Subject: MHI's Response to US-APWR DCD RAI No. 1036-7069 (SRP 06.02.02)

Response to Request for Additional Information No. 1036-7079

RAI NO.:	NO. 1036-7079
SRP SECTION:	06.02.02–Containment Heat Removal Systems
APPLICATION SECTION:	6.2.2
DATE OF RAI ISSUE:	05/20/2013

QUESTION NO.06.02.02-94:

Figure A-2 Containment Vapor Temperature

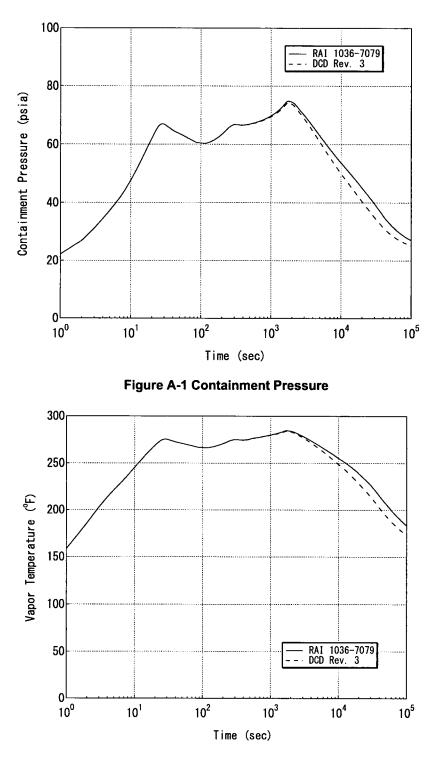
The sensitivity case results are shown in Table A-1. Peak containment pressure increased to 74.9 psia (60.2 psig) from 74.2 psia (59.5 psig). Pressure 24 hours after the incident is 28.0 psia (13.3 psig). Peak vapor temperature and RWSP liquid temperature in the containment increased to 285°F from 284°F and 253°F from 249°F, respectively. Comparisons between the sensitivity and DCD case are provided in the Figures A-1 through A-3.

Although the assumption of UA degradation was added to the original value that included the fouling factor effect, the calculated peak pressure is still under the design value, 82.7 psia (68 psig) with 10% margin to the design pressure. Containment pressure at 24 hours after the accident is within half of the calculated peak value. Therefore, the sensitivity case satisfies the NUREG-0800 SRP Acceptance Criteria 6.2.1.1A. In conclusion, even when overestimating the fouling factor of CS-RHR heat exchanger, there is no adverse effect to the design adequacy of the US-APWR containment system.
